RESPONSE TO REQUEST FOR ADDITIONAL INFORMATION

APR1400 Design Certification

Docket No. 52-046

RAI No.: 268-8308
SRP Section: SRP 19
Application Section: 19.1.
Date of RAI Issued: 10/02/2015

Figure 19.1-57 **LPSD Level 1 Event Tree – Total Loss of Component Cooling Water (TC) in POS 1**

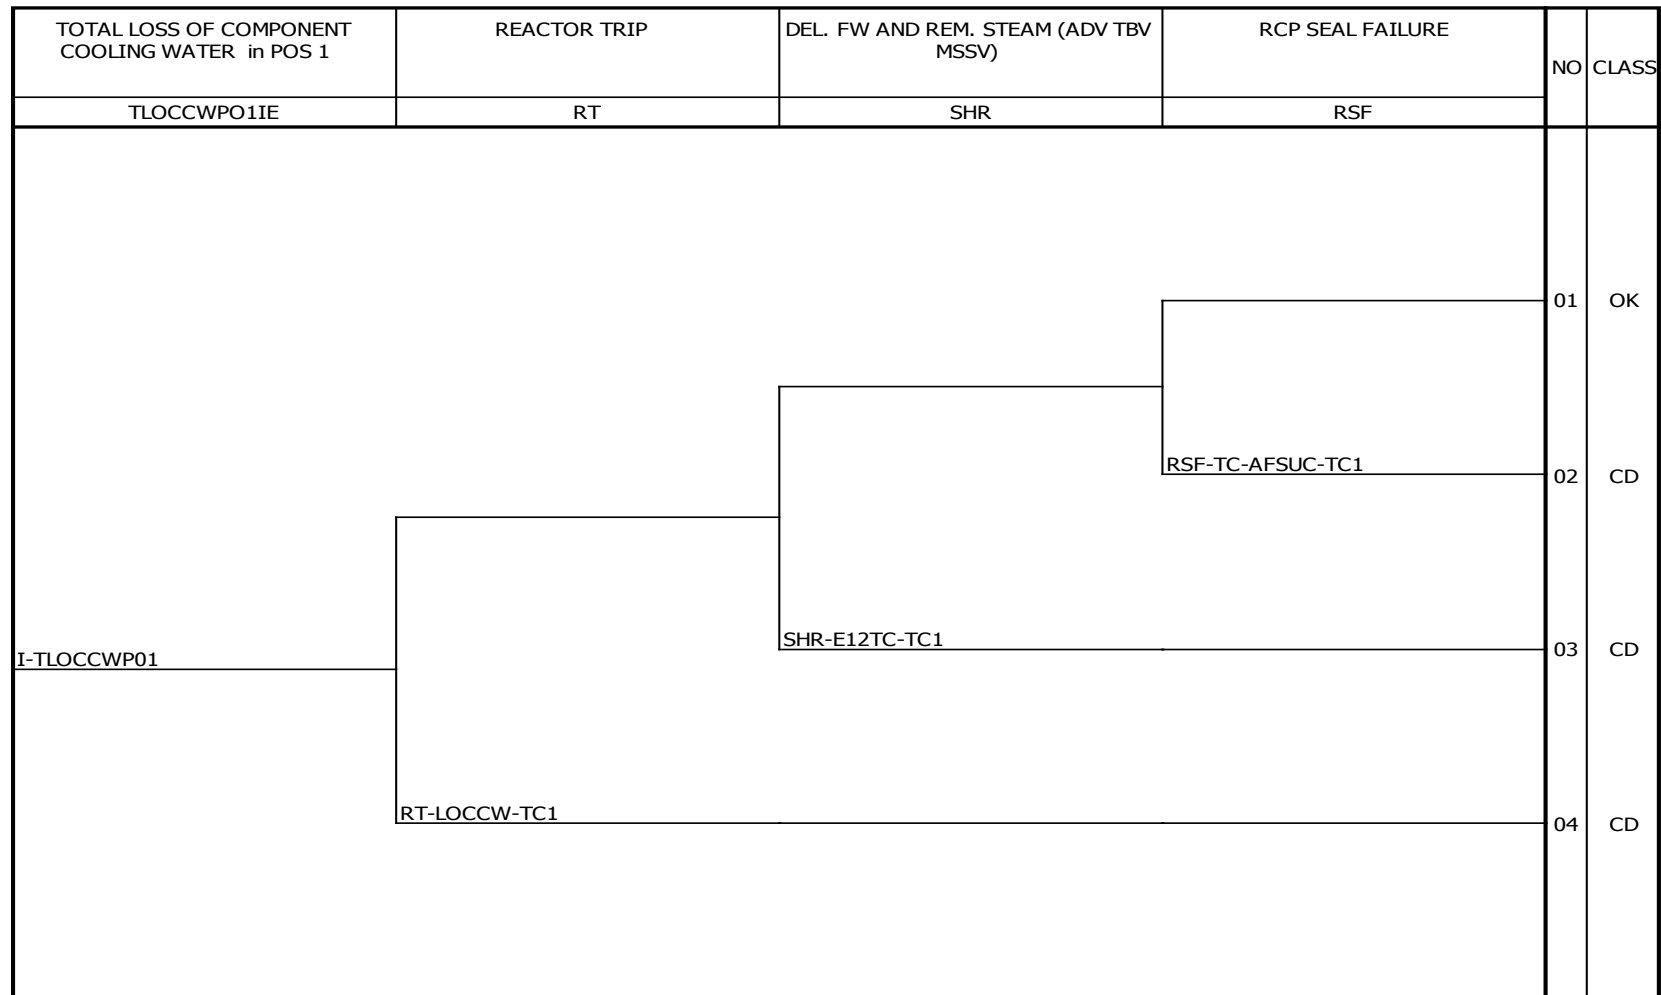
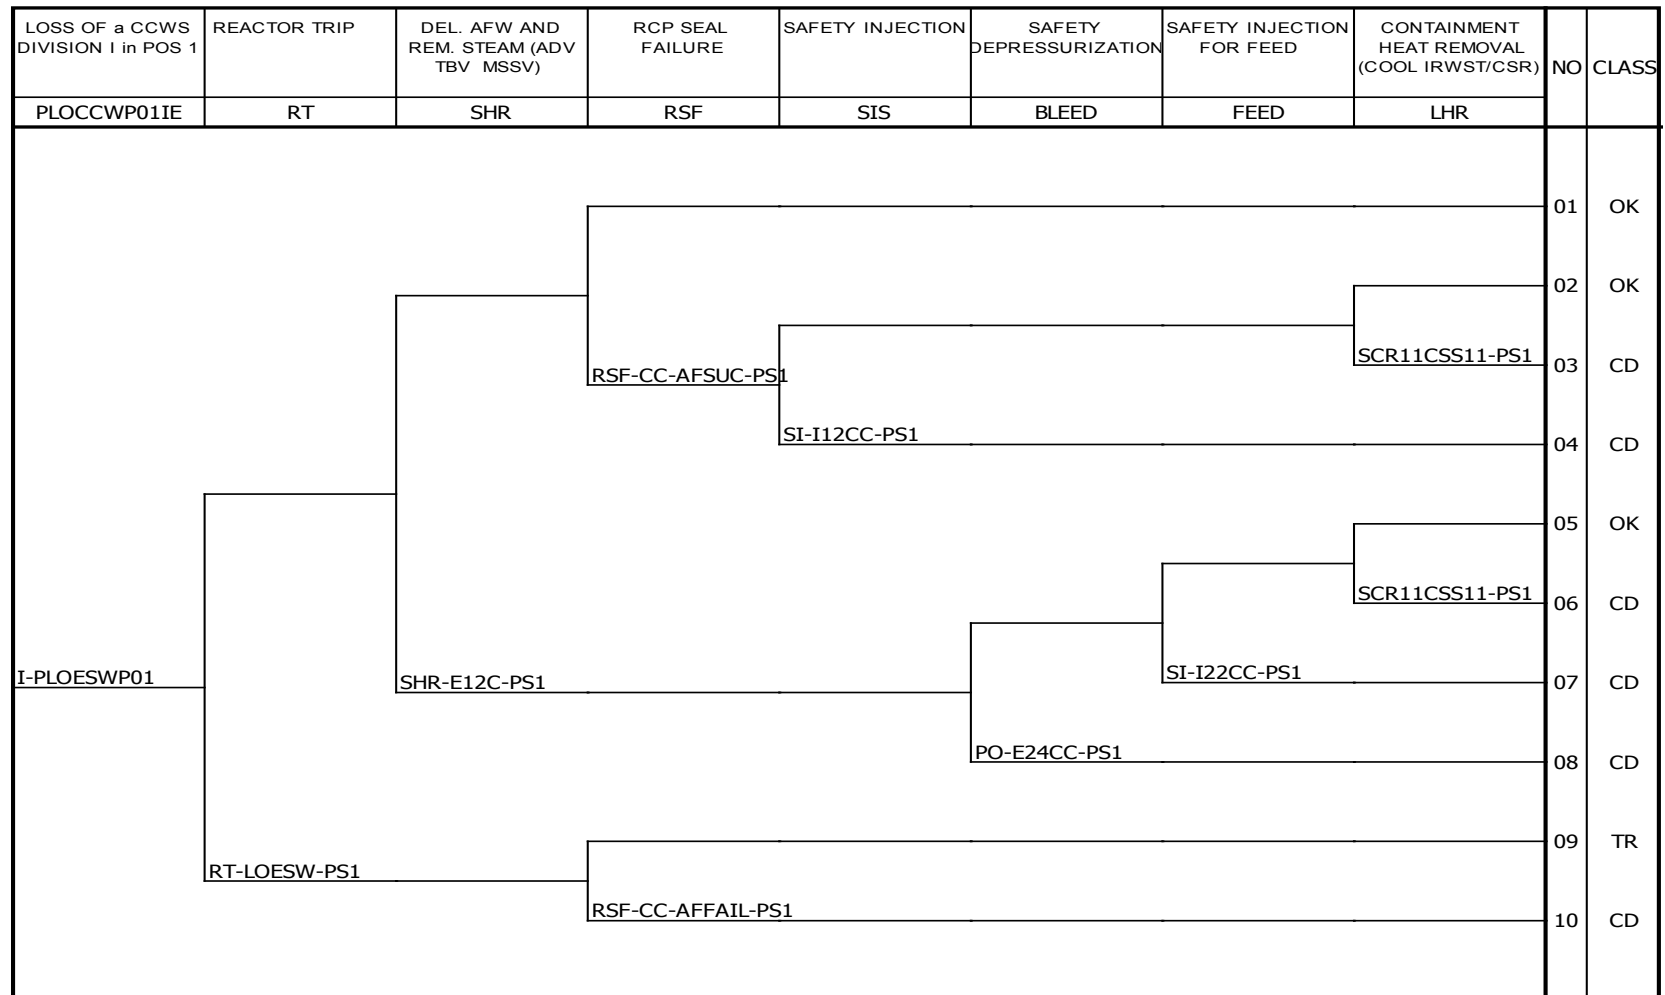
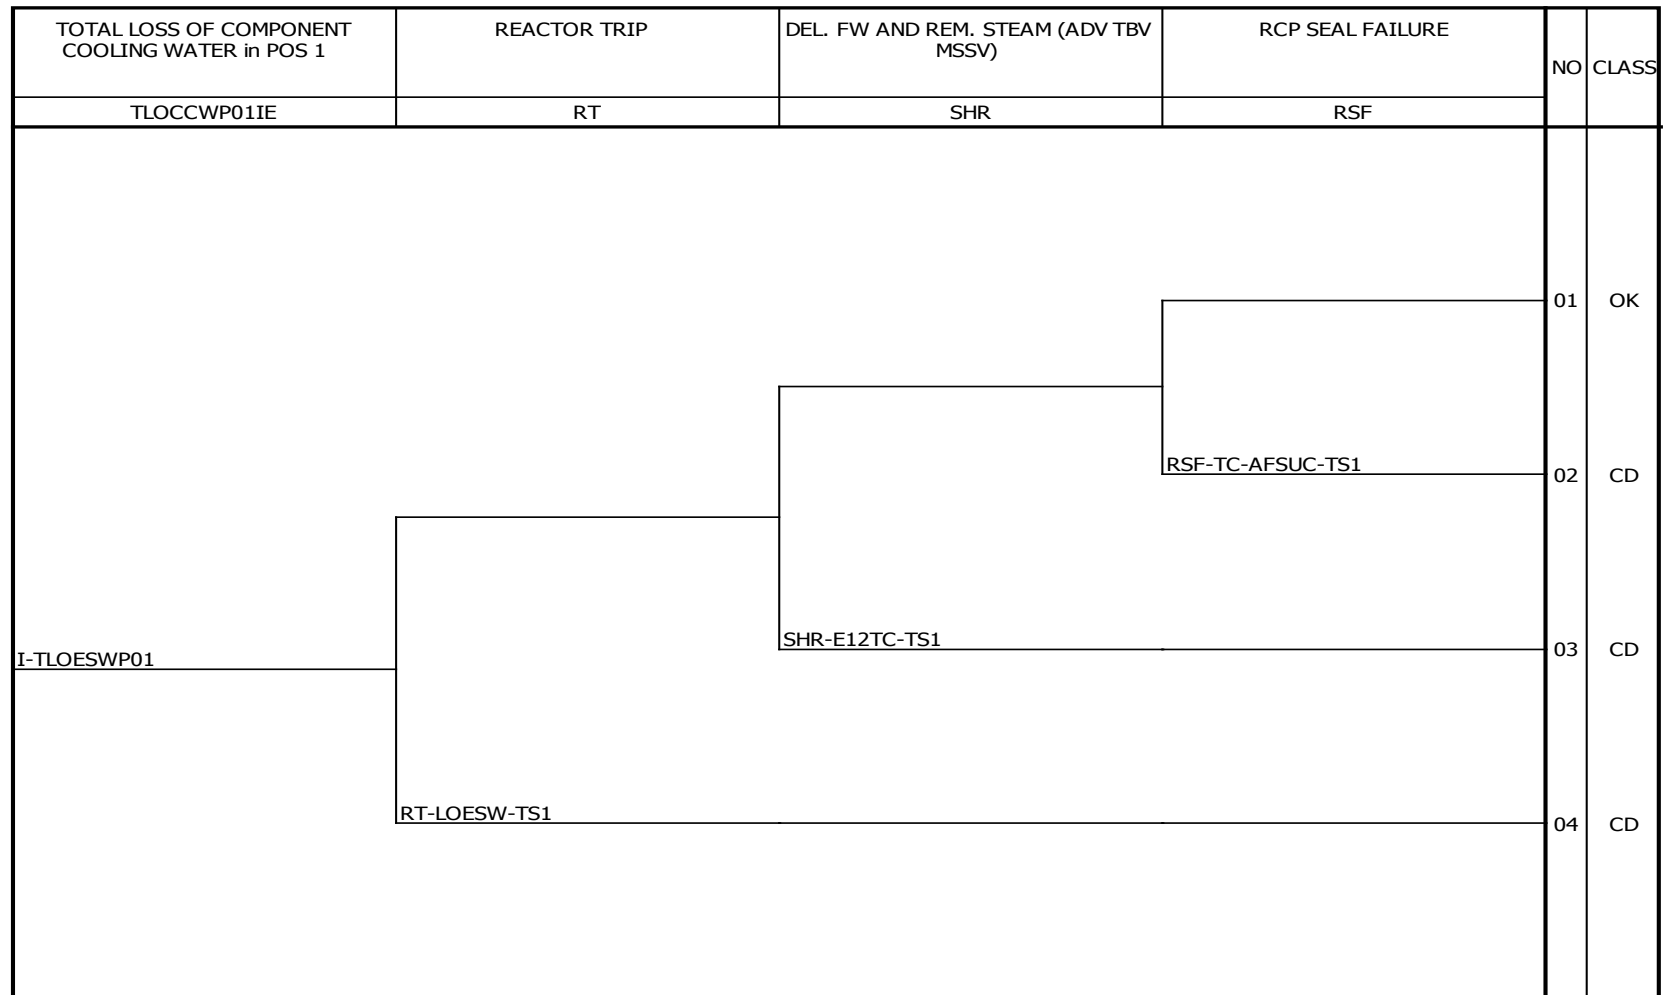
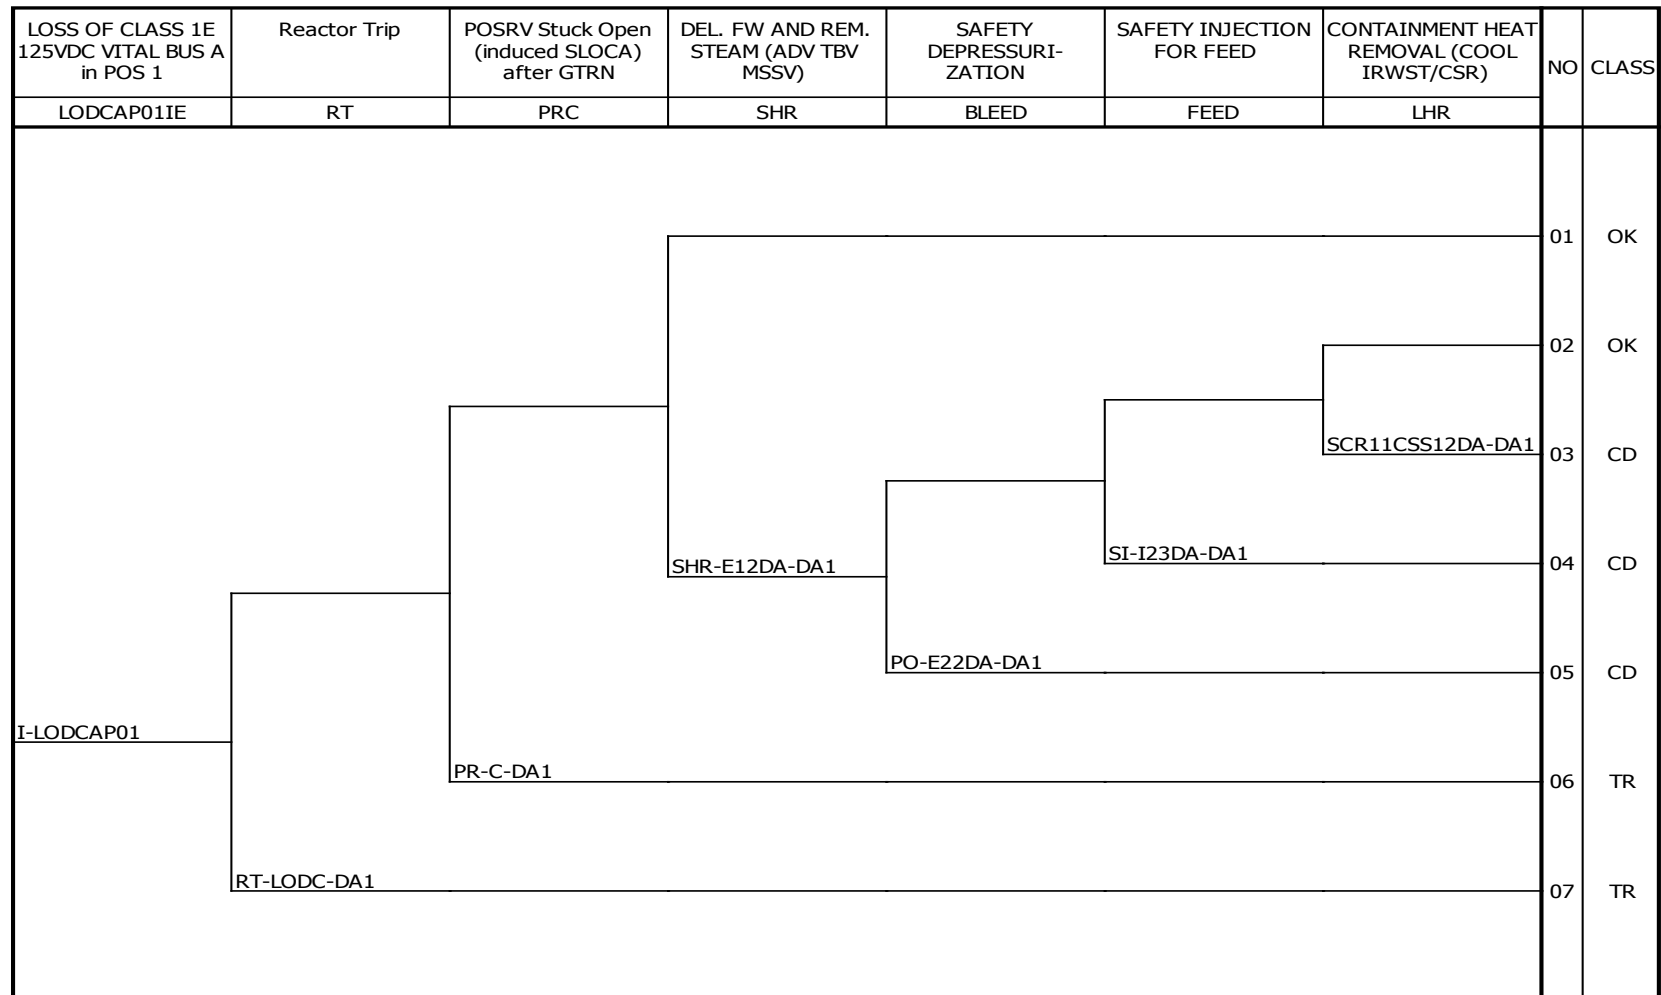
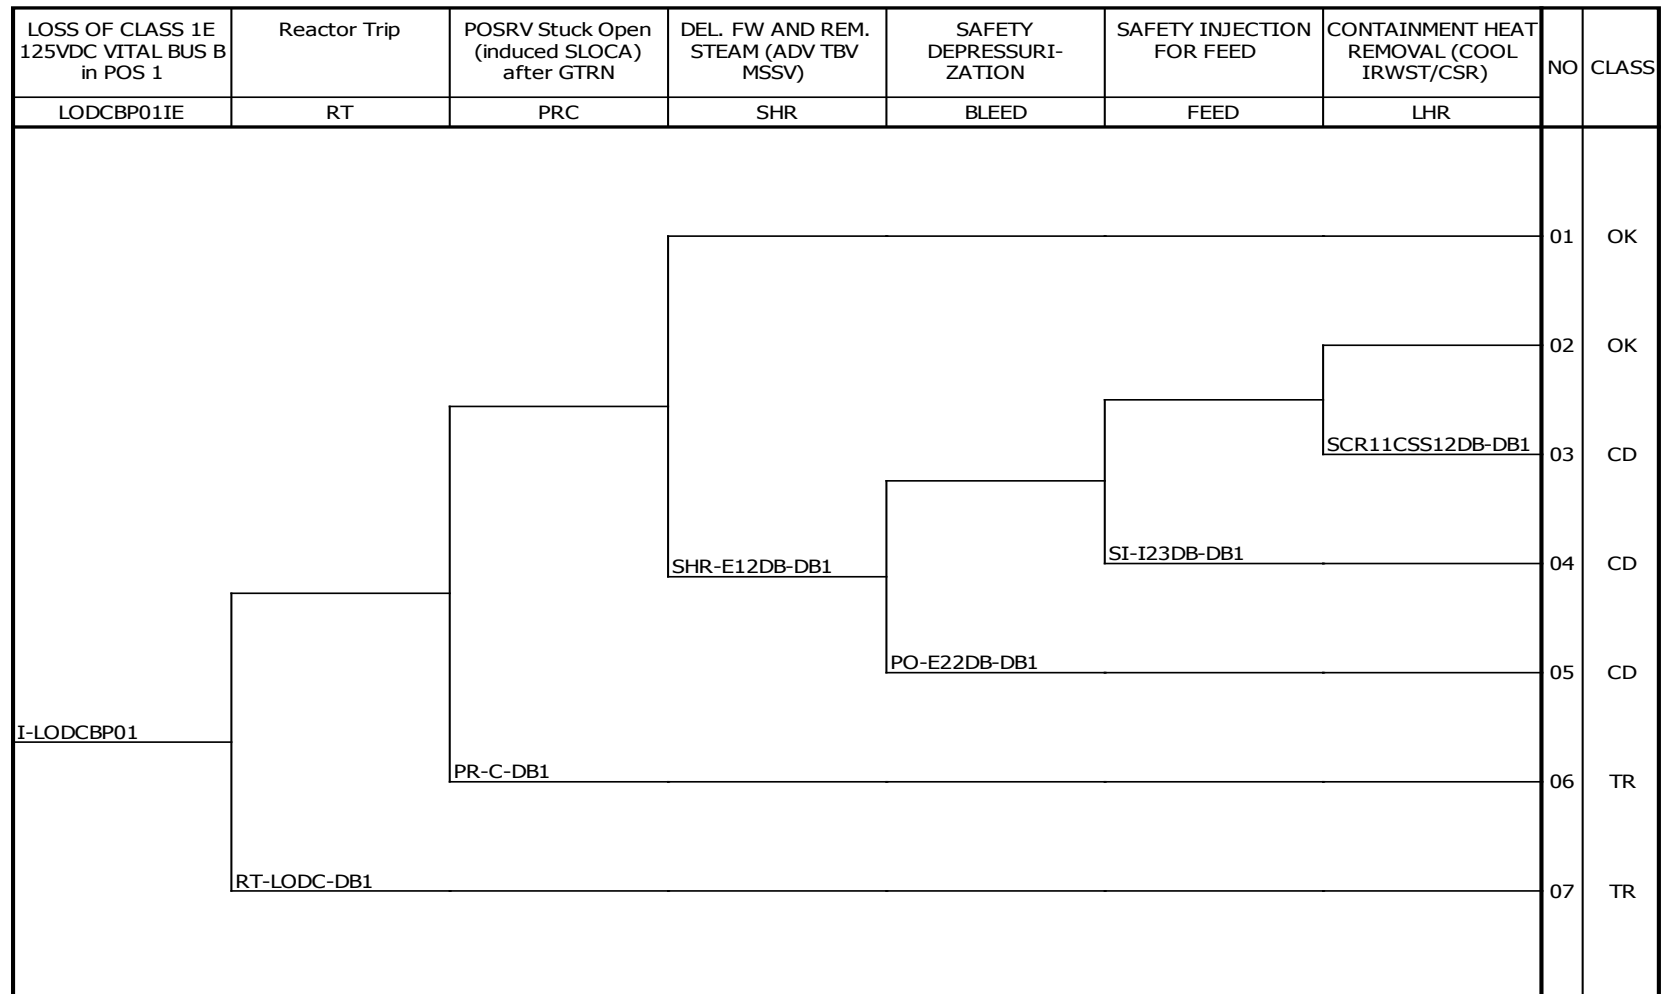
10 CFR 52.47(27) requires that a standard design certification applicant provide a description of the design specific PRA and the results. Design Control Document Section 19.1.6, appears to be missing event trees for all plant operational states other than plant operational state 5, which represents mid-loop conditions. However, the plant response to a loss of decay heat removal (DHR) is significantly different if the reactor coolant system (RCS) is intact versus an open RCS. To provide an example of how the different plant operational states were modeled in the probabilistic risk assessment (PRA), the staff is requesting that the applicant add the event trees for all plant operational states for the initiating event, loss of the operating train of the shutdown cooling (SDC) system. The staff considers these low power shutdown (LPSD) event trees part of the PRA results. These event trees will allow the reader to understand the varying plant response to a shutdown initiating event given the different plant operational states.

The twelve (12) event trees for POS 5 are included as Figures 19.1-52 through 19.1-63 in DCD 19.1. In response to this RAI, the low power and shutdown (LPSD) event trees for all plant operational states will be added to the DCD. The supporting discussion will also be revised.

The POS 5 LPSD event trees in Figures 19.1-52 through 19.1-63 will be supplemented to present the event trees for all plant operating states in Figures 19.1-52 through 19.1-208 and also figure for LPSD Containment Event Tree will be changed to Figure 19.1-209 as shown in the Attachment 1

~~The LPSD event trees for POS 5, which occurs during mid-loop operation, are contained in Figure 19.1-52 through Figure 19.1-63.~~

The LPSD event trees for all plant operational states (POSs) are presented in Figures 19.1-52 through 19.1-208. The LPSD containment event tree is presented in Figure 19.1-209.
